Checking the Hydraulic Pump Drive Pulley Hardware on IS5100Z Models

Figure 1. Checking the Torque of the Pulley Hardware
A. 1/4-20 x 1" Bolt
B. Tapered Hub Bushing
C. Hydraulic Pump Drive Pulley
D. Pump Plate Weldment

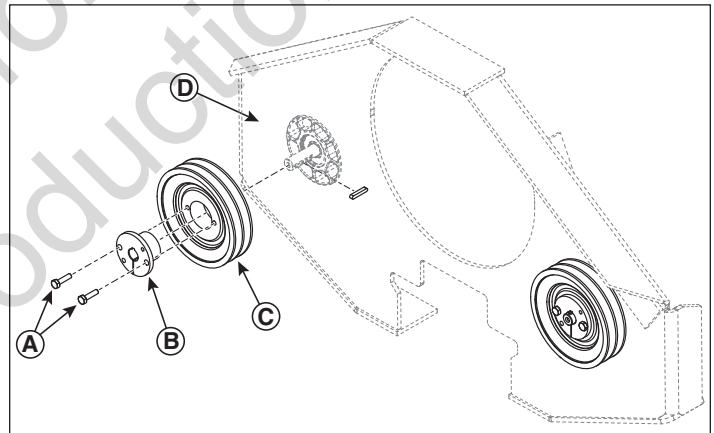
Ferris has determined that the hardware securing the hydraulic pump drive pulleys may not have been tightened to the correct torque specifications on the units detailed below. This details a procedure for inspecting the hardware and tightening the hardware if necessary.

NOTE: The hydraulic pump drive pulleys (**C**) should be spaced approximately 5/16" off of the pump plate (**D**).

1. Park the unit on a flat, level surface such as a concrete floor. Disengage the PTO, engage the parking brake, turn the ignition switch to OFF, and remove the key from the ignition.
2. Release the hood latch and raise the hood until it locks in place.
3. Remove the rear belt shield.
4. Using a 7/16" socket and a torque wrench, set the wrench to 120 in. lbs. (13.5 Nm) and check the torque of the two 1-4" bolts (**A, Figure 1**) on both tapered hub bushings (**B**) that secure the hydraulic pump drive pulleys (**C**).
5. If the bolts need tightening, alternate tightening the bolts back and fourth until you reach the correct torque specification.
